Access Compliance Report

Public Rights-of-Way

(Curb Ramps)

Intersection ID: 10023715	Main Street: COLEMON_KERRY_DR	Cross Street: N/A	Location: W
ADA ID: 590439C5AF72	Ramp Type: BlendTrans1	Initial Pass/Fail: Fail	Overall Compliance: No
		Severity Score: 10

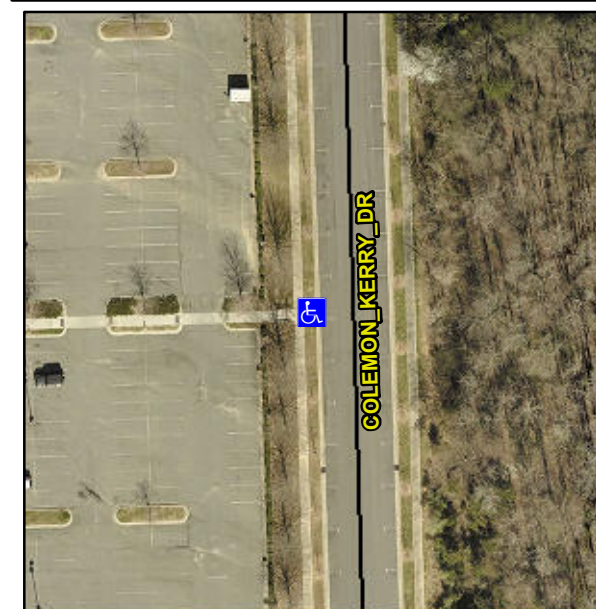
Not Found, R304.5.1, R304.5.3

Compliance	Description	Data	Compliance	Description	Data
N/A	Ramp Length (in)	74.0	Yes	BlendTrans Slope (%)	3.7
No	Ramp Width (in)	47.5	No	BlendTrans XSlope (%)	2.7
N/A	Flare Type LT	N/A	N/A	Flare Type RT	N/A
N/A	Flare Slope LT (%)	N/A	N/A	Flare Slope RT (%)	N/A
N/A	Flare Traversable LT?	N/A	N/A	Flare Traversable RT?	N/A
N/A	Landing Length (in)	N/A	N/A	DWS Provided?	N/A
N/A	Landing Width (in)	N/A	N/A	DWS Contrast?	N/A
N/A	Landing Slope (%)	N/A	N/A	DWS Length (in)	N/A
N/A	Landing X Slope (%)	N/A	N/A	DWS Full Width?	N/A
N/A	Landing Curb? (Y/N)	N/A	N/A	DWS Offset (in)	N/A
N/A	Shared Landing?	N/A			
N/A	Gutter Ponding?	N/A	N/A	Gutter Slope (%)	N/A
N/A	Gutter Lip Ht (in)	N/A	N/A	Gutter X Slope (%)	N/A
N/A	Painted X Walk1?	No	N/A	Painted X Walk2?	N/A
	X Walk 1 Direction	To E		X Walk 2 Direction	N/A
	X Walk 1 Width (in)	N/A		X Walk 2 Width (in)	N/A
	X Walk 1 Slope (%)	2.8		X Walk 2 Slope (%)	N/A
	X Walk 1 X Slope (%)	2.3		X Walk 2 X Slope (%)	N/A

N/A	Ramp inside XWalk1?	N/A	N/A	Ramp inside XWalk2?	N/A
	Road Slope (%)	2.3		Clear Space?	N/A
	Road X Slope (%)	2.8	N/A	Clear Space to XWalk (in)	N/A
N/A	Any Obstructions?	N/A	N/A	Storm Grate/Utility Hazard?	N/A
	Obstruction Type			Storm Grate/Utility Type	
		N/A			N/A
			Yes	Surface Condition? (G/P)	Good
			No	Curb Slope (%)	16.2

Remove & Replace Curb Ramp With Two New Directional Ramps or Equivalent.
